Groundwater Transfer Review Summary Form

Transfer/PA # T- <u>14351</u>

GW Reviewer <u>James Hootsmans</u> Date Review Completed: <u>6/17/2024</u>

T-14351 Brazelton SW to GW

Stream Depletion from To-POA 1 and 2

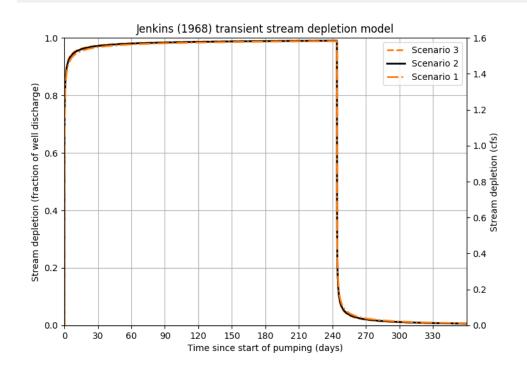
Yes Do Comments: <u>All proposed To-POA will be constructed in unconfined</u> alluvium in the McKenzie River alluvial floodplain, which is bounded by basalt flows to the north and south. Using Jenkins stream depletion model, and the distance of the POAs in relation to the river, the proposed To-POAs would affect the surface water similarly to the authorized POD (See stream depletion figures below).
